Fourth Floor Plan as Proposed

JV ARCHITECTS Garden Studios, 11-15 Betterton Street Covent Garden, London WC2H 9BP Tel: 020 7470 8873 020 8340 5665 Tel/fax: 020 8340 5661	
Client: FASTLANE PRODUCTIONS LTD	
Site: 27 Tottenham Street London W1T 4RW	
Drawing Title: Fourth Floor Plans as Proposed	
Dwg. No. 12/313/16	Rev. A
Scale: 1:50	
Date: June 2012	
Drawn by: PJK

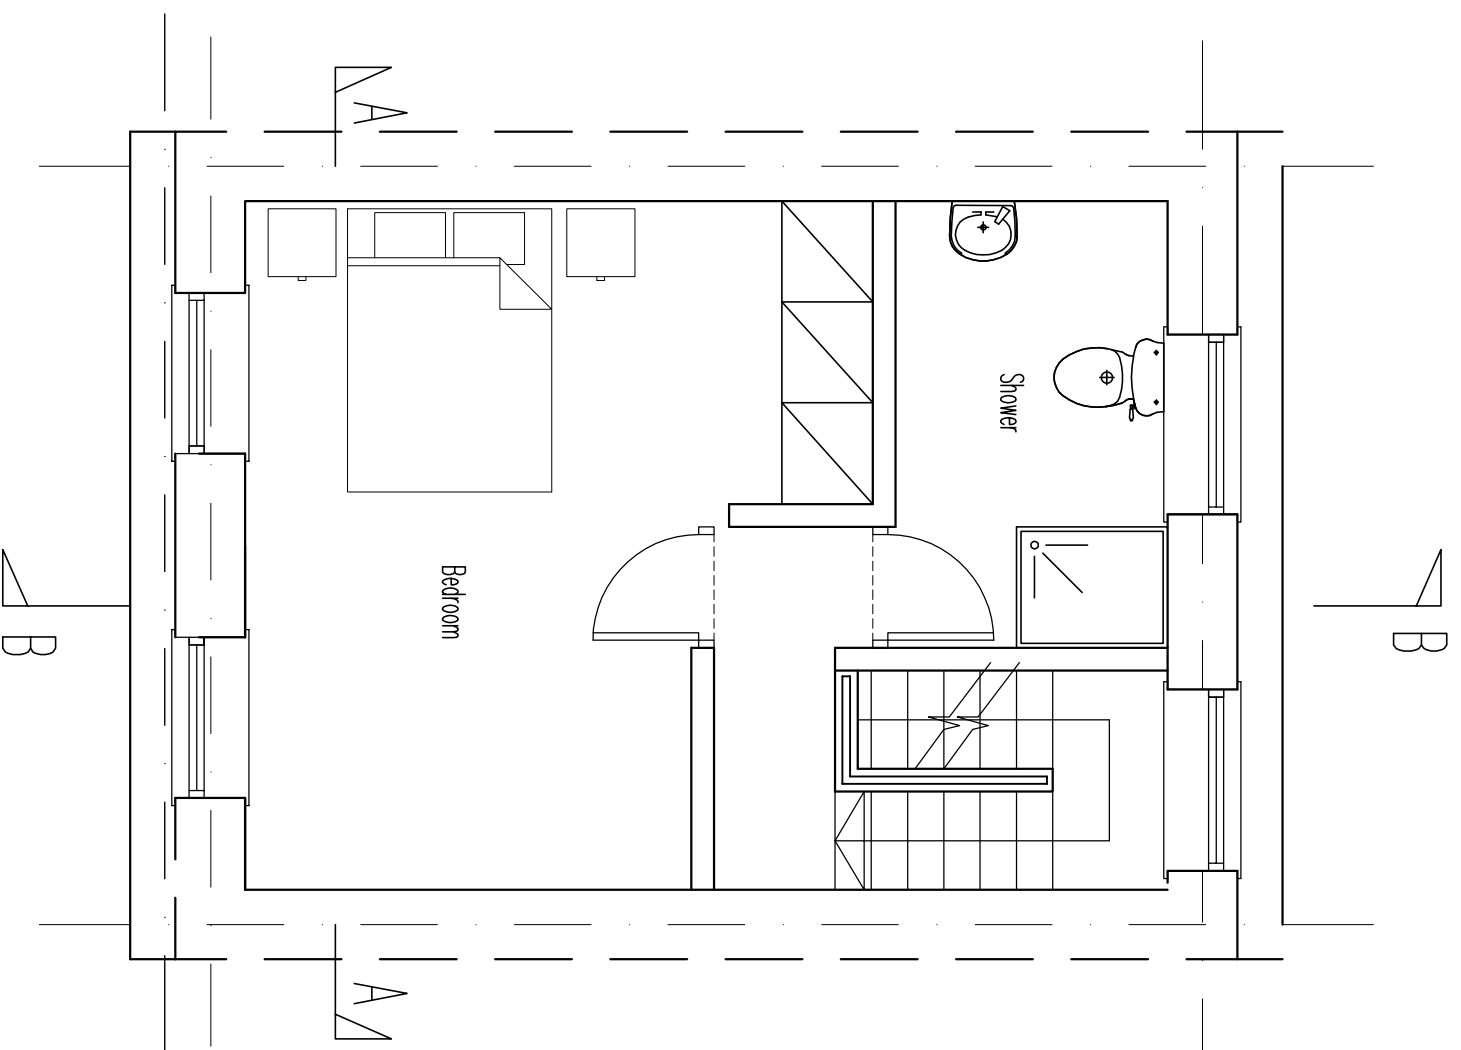
A. 3rd and 4th Floor Revised to 1xbed
maisonette with floor below
